## **SERVICE BULLETIN**

- TO:** Owner/Operators of Pacific Scientific Company Restraint Systems using Buckle Assembly Part Numbers 1111430-XX and 1111475-XX.
- SUBJECT:** Information regarding the potential failure of the Guarded Rotary Buckle plastic handle.
- PURPOSE:** This Service Bulletin (SB) identifies suspect Buckle Assemblies and advises operators to return them to Pacific Scientific for exchange/replacement.

Figure 3

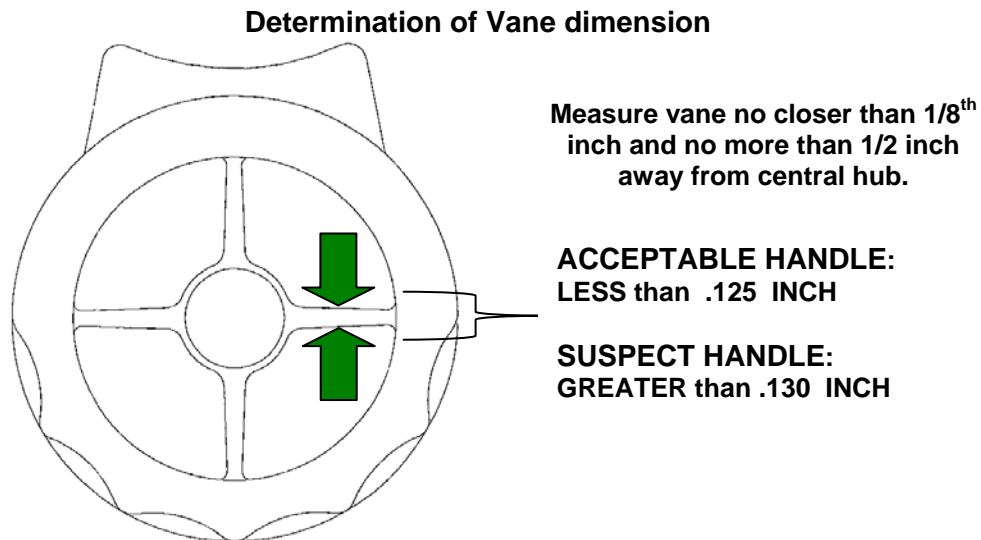
Suspect handles may also be identified by measuring the thickness of the handle vane. Measurement to determine suspect handles will be accomplished in accordance with Figure 3.

**ACCEPTABLE PARTS** will have a vane dimension **LESS** than **.125 INCH**

**SUSPECT PARTS** will have a vane dimension **GREATER** than **.130 INCH**

A GOLD center logo plus oversize vanes are indicators of suspect parts. Handles that have been reworked are marked with a BLUE logo on the center button. (See figure 4). These handles are acceptable and do not require replacement.

**Figure 5**

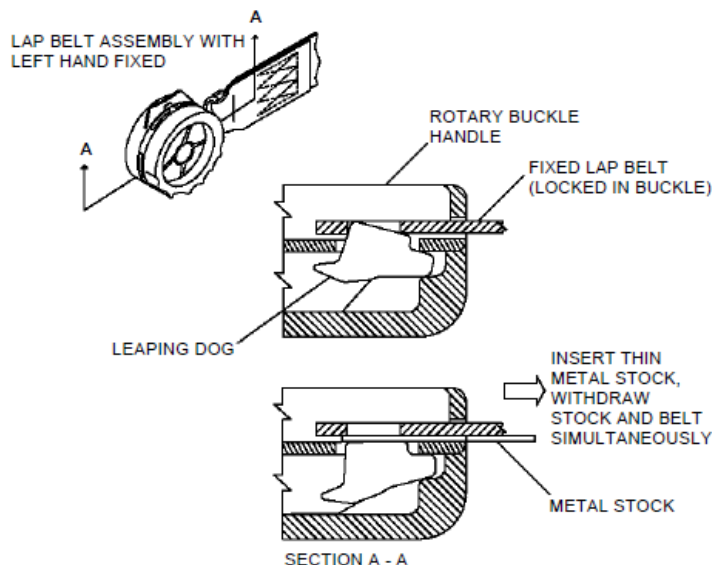
Remove suspect buckle from fixed lap belt by sliding a shim between the fixed belt fitting and back of buckle assembly;

- 1) Insert a piece of thin metal stock into the slot of the rotary buckle and push inward between the fitting and the buckle locking mechanism (see Figure 5)
- 2) Pull the strap from the buckle
- 3) Remove the buckle pad as necessary.

To reassemble with acceptable buckle, insert lap belt into new buckle. Fixed strap location is indicated by appropriate marking on buckle housing. Additional detailed instructions are available in ACMM 25-11-59 should they be required.
